**CORRIGENDUM / ADDENDUM TO TENDER DOCUMENT- OFFICE PREMISES AT BHOPAL DATED
10/04/2019**

(A) CORRIGENDUM- Tender No- 402/2020/1447

**Modification in Tender Documents already hosted by SIDBI in respect of
Tender No- 402/2020/1447 seeking invitation of offers for acquiring office premises on Leave and
License/Lease basis at Bhopal, Madhya Pradesh**

Network Cabling Diagram (for illustration purpose only)

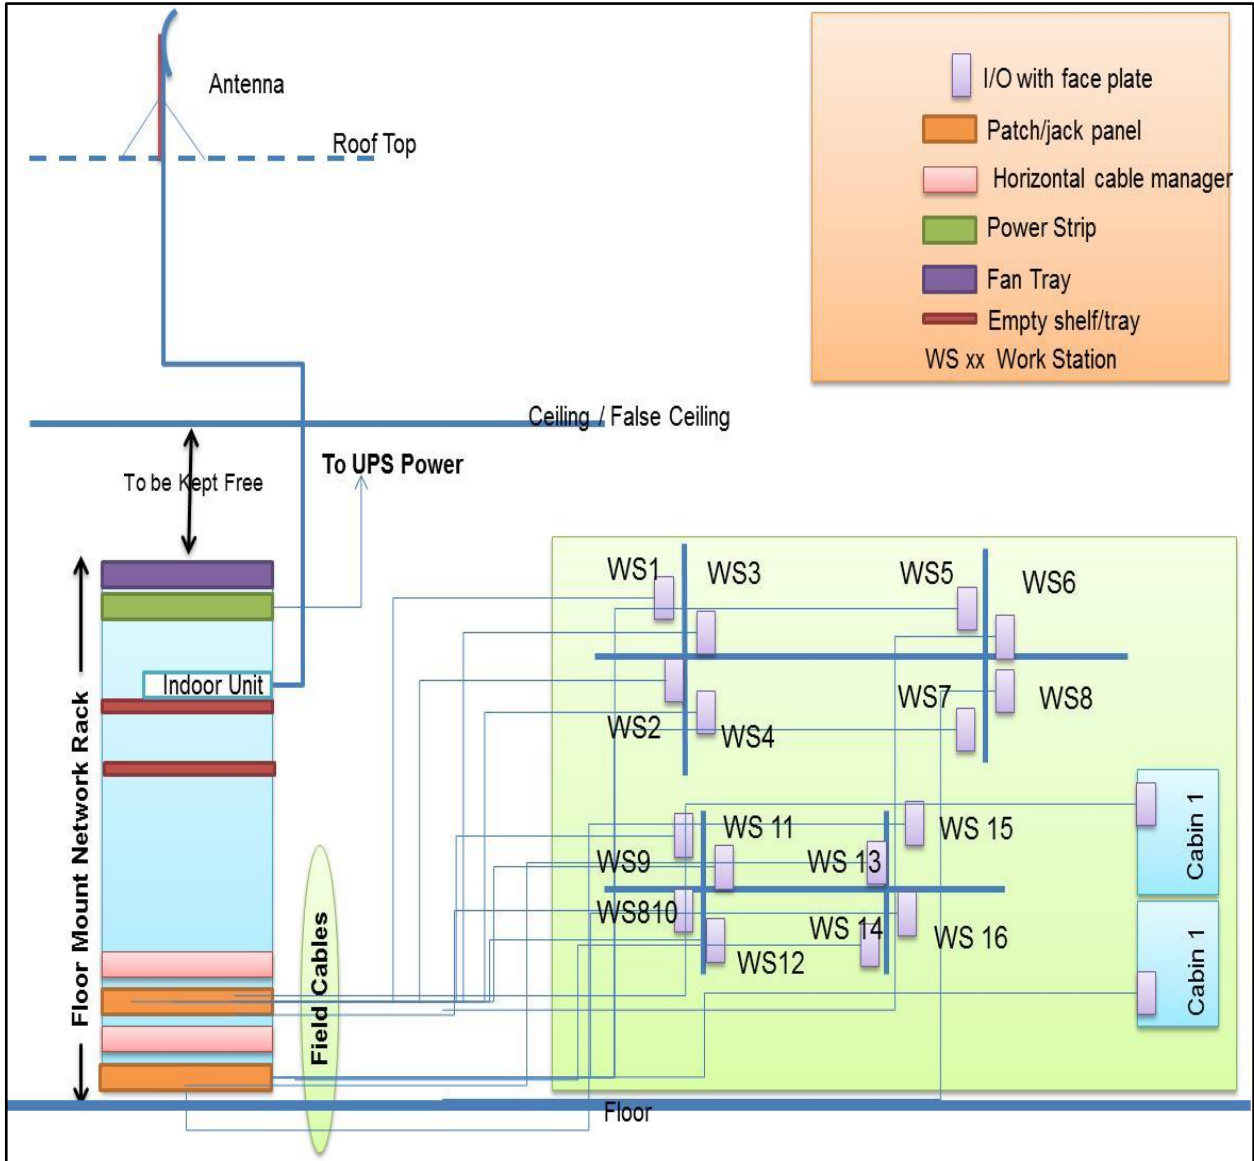
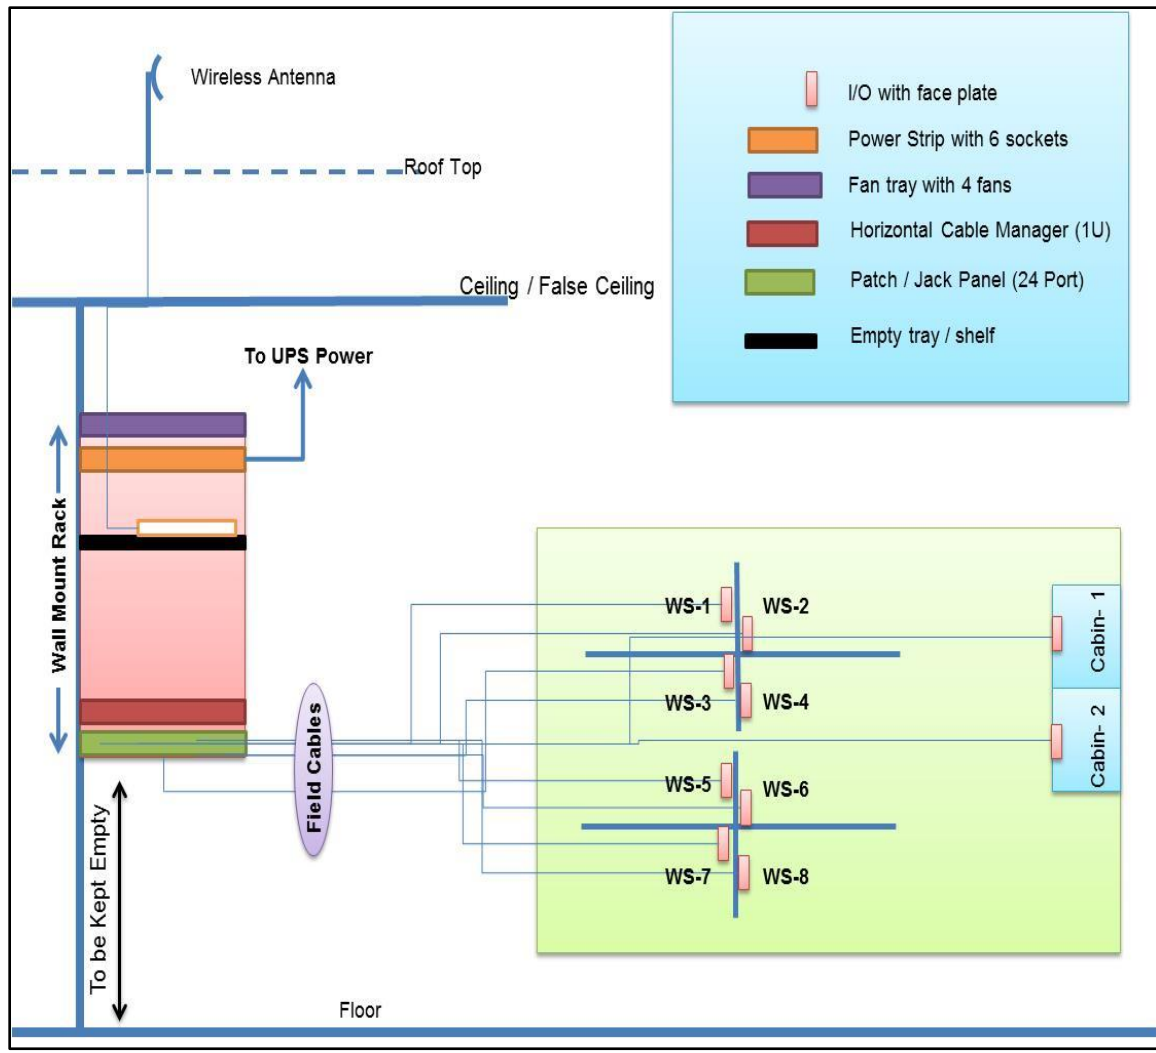
| | | <p>wall mount rack, the space below the rack should be kept open for future requirements / expansions.</p> <p><u>(b). Cabling</u></p> <p>(i). Surface mount Information Outlet (I/O) boxes with connectors affixed to the partition along with face plate one each at each workstation/ cubical/ cabin/ conference room and for printers.</p> <p>(ii). All field cables originating from workstation / cubical/cabin/conference room/printer should be terminated / crimped to the patch / jack panels. Numbering of cables at both ends and on patch/jack panel to be carried out.</p> <p>(iii). All field cables within the bank premises should be laid through PVC conduit along a duct.</p> <p>(iv). All ports on patch panel, I/O and cables should be properly tagged for easy identification. Complete LAN diagram to be provided.</p> <p>(v). All cables and passive components (I/O, patch/jack panel etc for LAN connectivity should be CAT 6 only.</p> <p>(vi). Total Number of Network Points - 15</p> <p>c). For illustration purpose structured cabling diagram is given in Appendix –ii.</p> |

1. The diagrams are for illustration purpose only.
2. The size of rack, number of - patch/jack panels, Horizontal cable manager, empty shelves/trays etc. are as per RfP specifications.
3. **Floor Mount Rack**

4. **Wall Mount Rack**
